Access Compliance Report

Public Rights-of-Way (Curb Ramps)

Intersection ID: 3757	Main Street: DAVIS_LAKE_PY	Cross Street: POPLAR_GROVE_DR	Location: SE
ADA ID: 618A17DFA1DA	Ramp Type: Perp	Initial Pass/Fail: Fail	Overall Compliance: No
Severity Score: 12.5			
Codes/Mitigation Info/Possible Solution		Field Measurements/Component Compliance

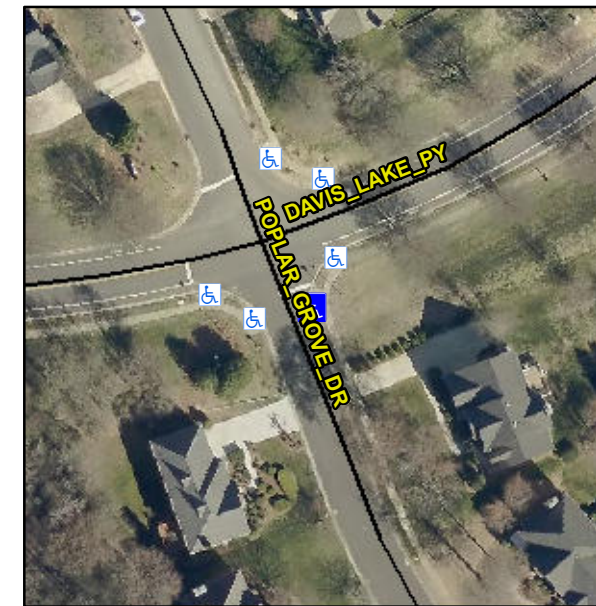
Not Found, R304.2.2

Compliance	Description	Data	Compliance	Description	Data
N/A	Ramp Length (in)	46.0	No	Ramp Slope (%)	9.5
Yes	Ramp Width (in)	48.0	Yes	Ramp XSlope (%)	1.9
N/A	Flare Type LT	N/A	N/A	Flare Type RT	N/A
N/A	Flare Slope LT (%)	N/A	N/A	Flare Slope RT (%)	N/A
N/A	Flare Traversable LT?	N/A	N/A	Flare Traversable RT?	N/A
N/A	Landing Length (in)	N/A	N/A	DWS Provided?	N/A
N/A	Landing Width (in)	N/A	N/A	DWS Contrast?	N/A
N/A	Landing Slope (%)	N/A	N/A	DWS Length (in)	N/A
N/A	Landing X Slope (%)	N/A	N/A	DWS Full Width?	N/A
N/A	Landing Curb? (Y/N)	N/A	N/A	DWS Offset (in)	N/A
N/A	Shared Landing?	N/A			
N/A	Gutter Ponding?	N/A	N/A	Gutter Slope (%)	N/A
N/A	Gutter Lip Ht (in)	N/A	N/A	Gutter X Slope (%)	N/A
N/A	Painted X Walk1?	No	N/A	Painted X Walk2?	N/A
	X Walk 1 Direction	To W		X Walk 2 Direction	N/A
N/A	X Walk 1 Width (in)	N/A	N/A	X Walk 2 Width (in)	N/A
	X Walk 1 Slope (%)	2.8		X Walk 2 Slope (%)	N/A
	X Walk 1 X Slope (%)	3.2		X Walk 2 X Slope (%)	N/A

Remove & Replace Entire Ramp.
